CITY PLANNING COMMISSION
 1231 "I" STREET, SUITE 200, SACRAMENTO, CA 95814

- A. Negative Declaration
- B. Special Permit to construct a 58 seat, 2,355 square foot Jack-in-the-Box restaurant on 0.83± vacant acres in the Shopping Center (Planned Unit Development) (SC{PUD}) zone.
- C. Special Permit to allow a restaurant with a drive-through window in the SC(PUD) zone.

SW quadrant of West El Camino Avenue & Gateway Oaks Drive

P90-426

PROPOSED SITE PLAN
 3/14/91

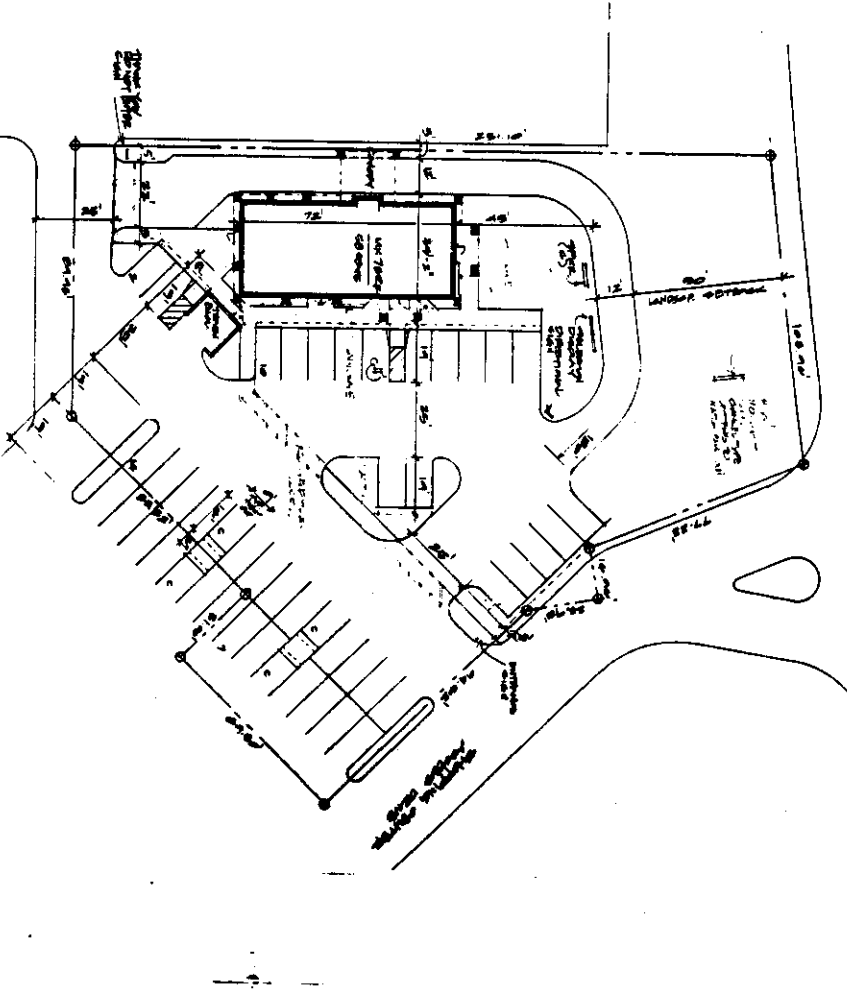
The submitted site plan indicates a 50 foot landscape setback along West El Camino. One driveway entrance/exit is shown off of West El Camino Avenue. A trash enclosure is indicated at the rear portion of the lot. The building and landscape setbacks reflected on the site plan are consistent with the PUD Guidelines. The proposed trash enclosure shall comply with the City's Trash Enclosure Ordinance. The applicant also submitted a landscape and irrigation plan which reflects adequate landscaping around the entire restaurant area and parking area. It is recommended that all paved areas meet the 50 percent shading requirement.

The submitted site plan indicates on monument sign, several directional signs and speakers with an associated outdoor menu board. The PUD Guidelines allow two attached signs for each free-standing building and only one identification sign (monument sign) is allowed for the entire shopping center. The proposed signage, therefore, does not comply with the PUD Guidelines. It is recommended that all signage proposed complies with the approved sign criteria of the PUD Guidelines.

- 1. All signage shall comply with the Natomas Eastside/Natomas Associates approved guidelines for the PUD.
- 2. The proposed restaurant shall be redesigned to eliminate the drive-up window prior to issuance of final building permits.

- 3. The trash enclosure shall comply with the City's Trash Enclosure Ordinance.
- 4. All paved areas shall meet the 50 percent shading requirement.
- 5. Reciprocal ingress, egress, parking, maneuvering and drainage easements required.

WEST ELEVATION

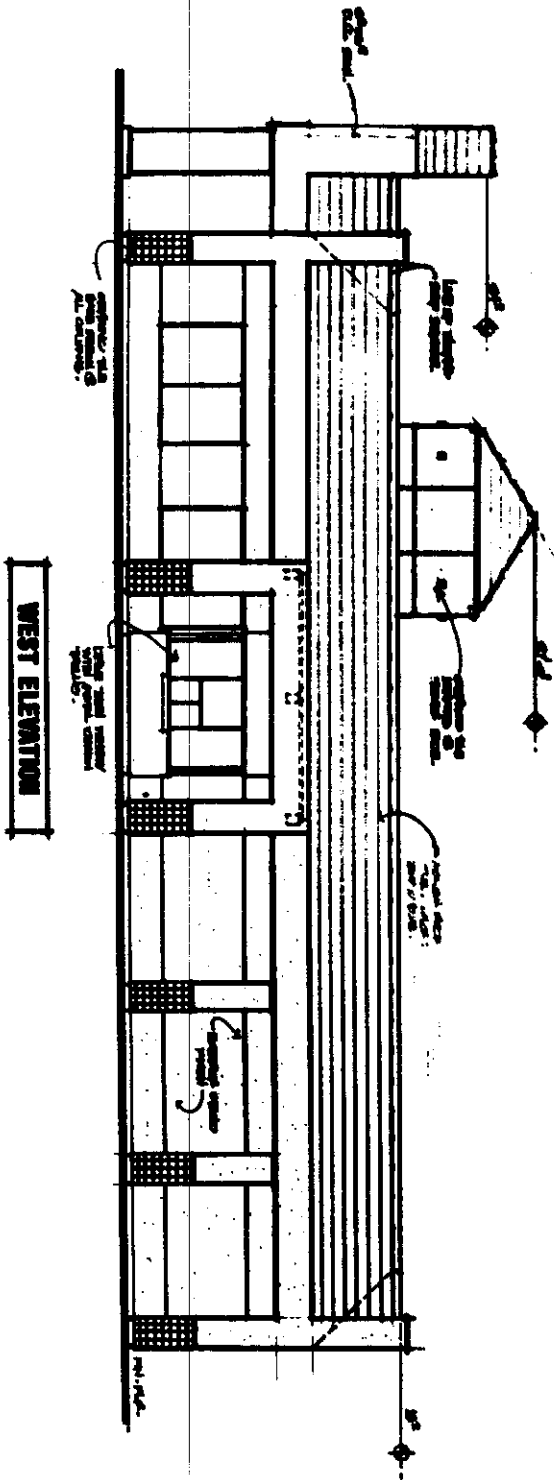
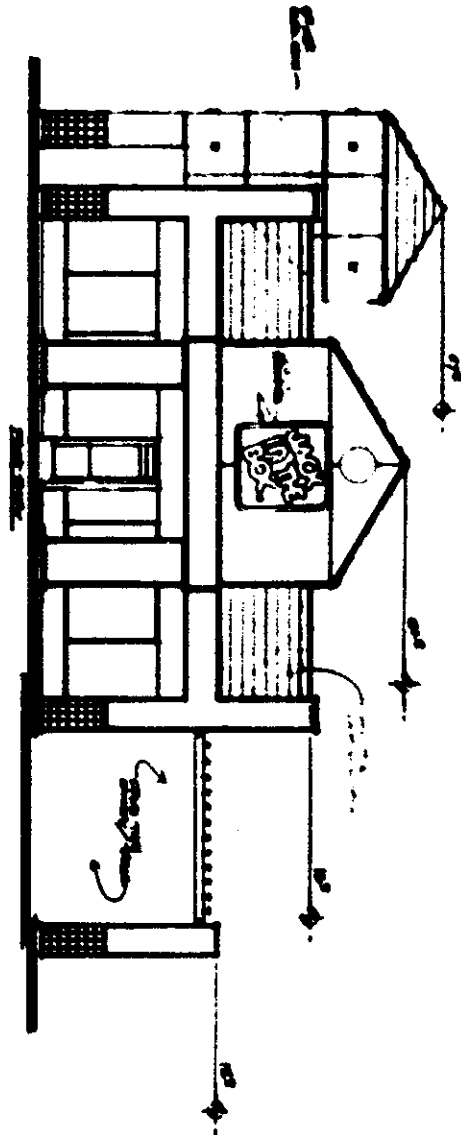
The applicant submitted floor plans and elevations for the restaurant use. The proposed building material consists of a stucco finish with metal roofing similar to the existing shopping center. Ceramic tile is proposed to be located at the base of each column. Overall staff feels that the proposed building design is compatible to the existing shopping center. The proposed building design is in compliance with the PUD Guidelines.
